# Access Compliance Report

## Public Rights-of-Way

Intersection ID: 45246	Main Street: BEGONIA_DR	Cross Street: KODIAK_CT	Location: SE
ADA ID: 3F0748D3C7C0	Ramp Type: BlendTrans1	Initial Pass/Fail: Pass	Overall Compliance: No
Severity Score: 5.25			
Codes/Mitigation Info/Possible Solution		Field Measurements/Component Compliance

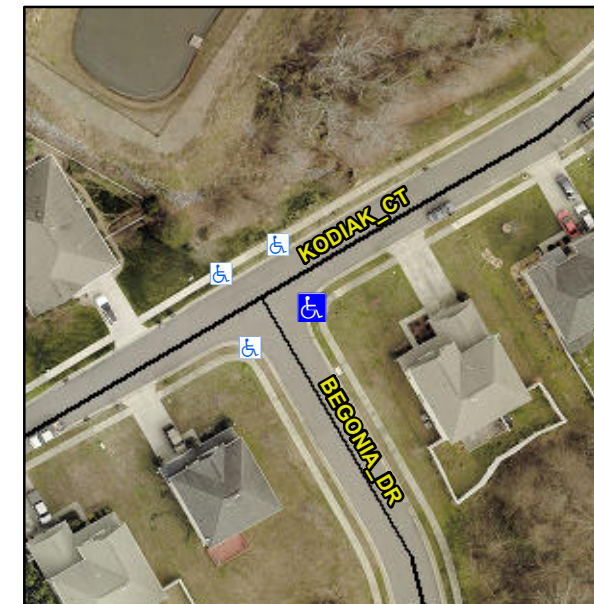
**CURB GAP 1.5**

**Not Found, R304.5.3, R304.2.1, R302.7, R304.5.4**

**Remove & Replace Curb Ramp With Two New Directional Ramps or Equivalent. Remove & Replace Gutter.**
